SUBJECT: ISSUANCE OF AMENDMENT FOR INDIAN POINT NUCLEAR GENERATING
 UNIT NO. 3 RE: RADIOACTIVE EFFLUENT TECHNICAL SPECIFICATIONS (TAC
 NO. MA6225)

Amendment No. 199
License No. DPR-64

ATTACHMENT TO LICENSE AMENDMENT NO. 199

Information regarding radioactive gaseous and liquid effluents, which will allow identification of structures and release points as well as definition of UNRESTRICTED AREAS within the SITE BOUNDARY that are accessible to MEMBERS OF THE PUBLIC, shall be shown in Figure 4.7-1.

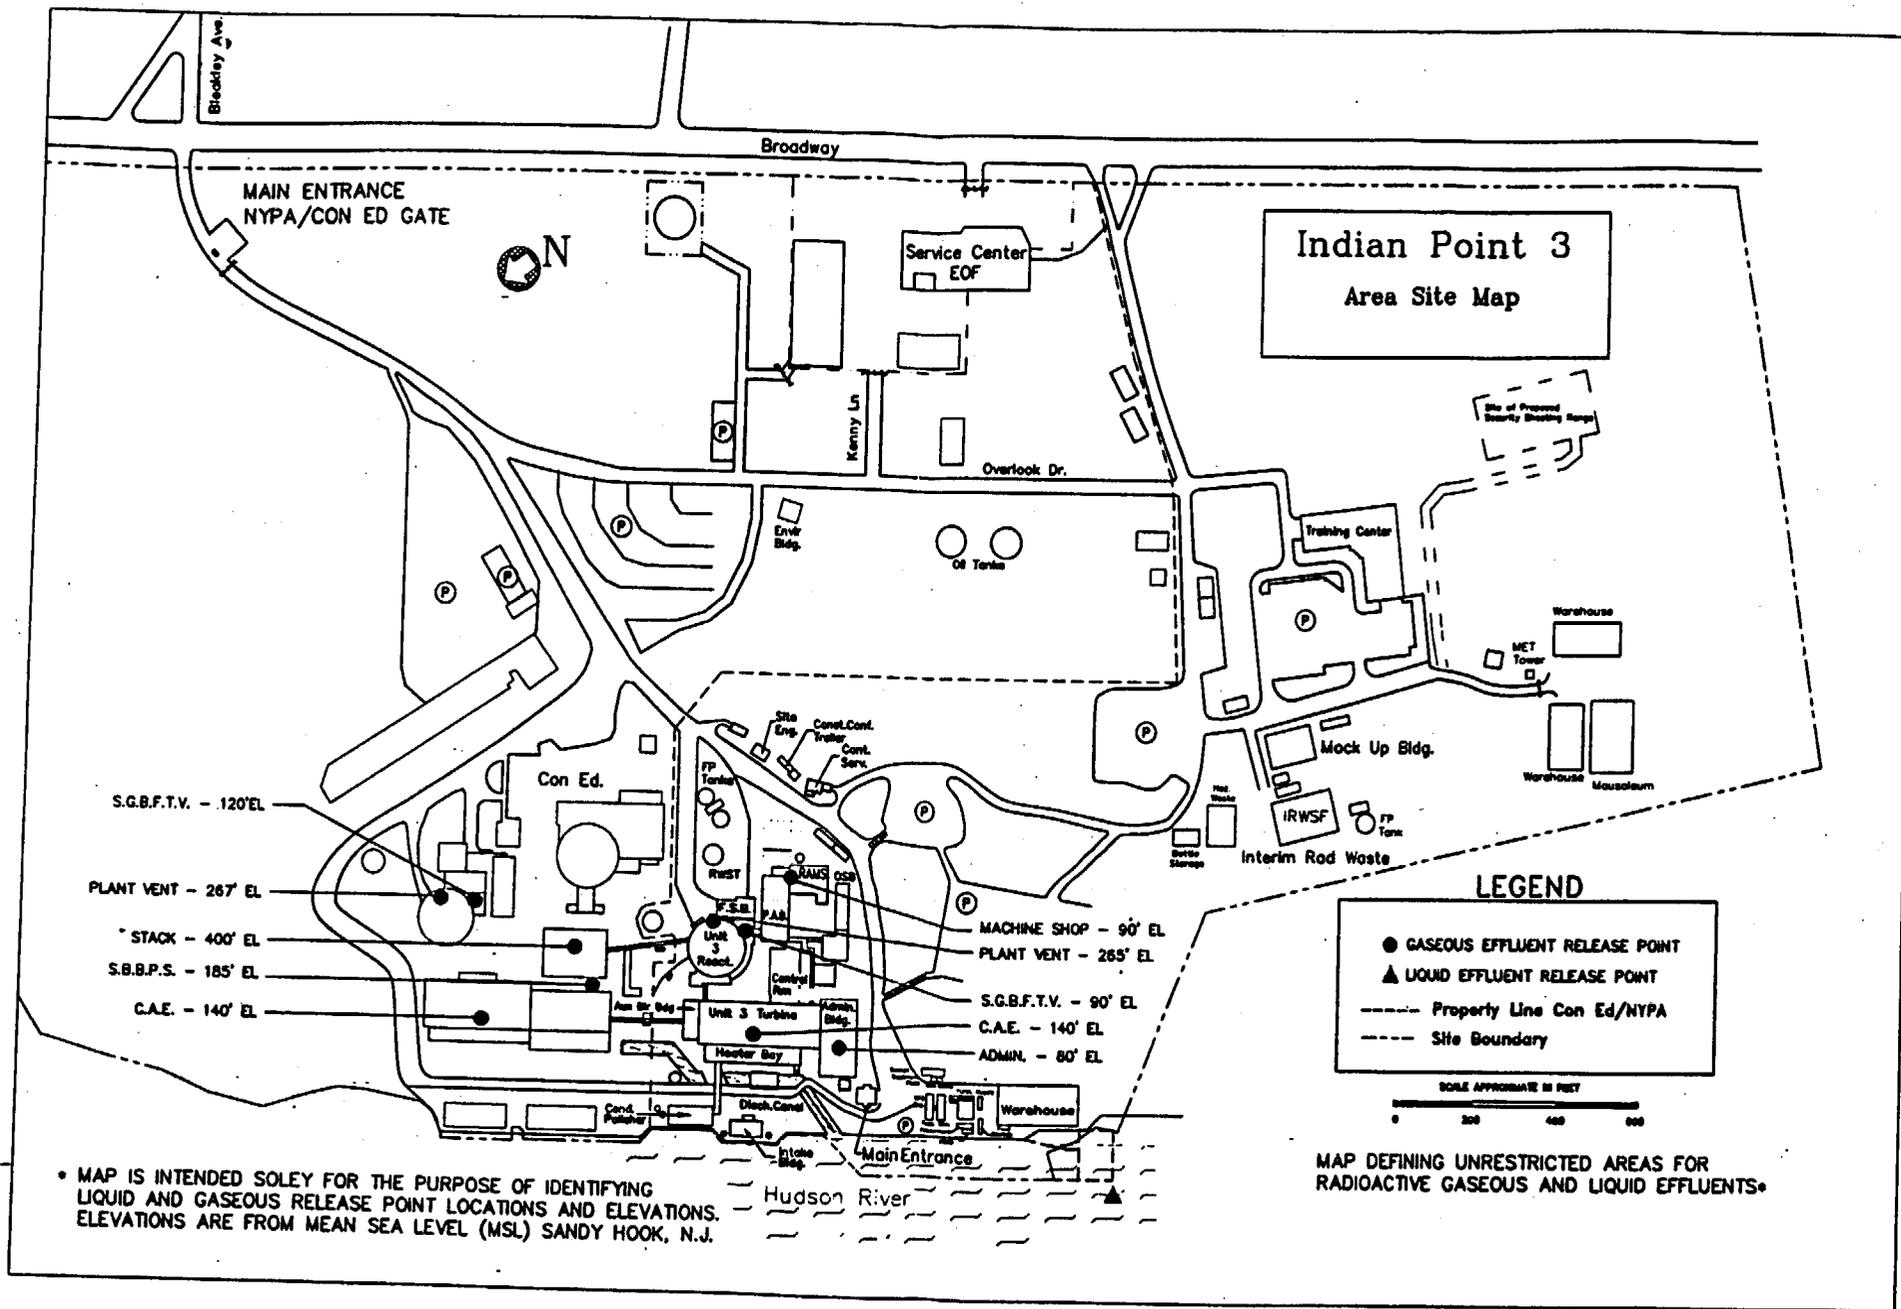
Part II of Appendix B, Technical Specification 5.8 and Figure 5.1-1 are being updated to reflect revised definitions and to reference the applicable Part 20 sections.
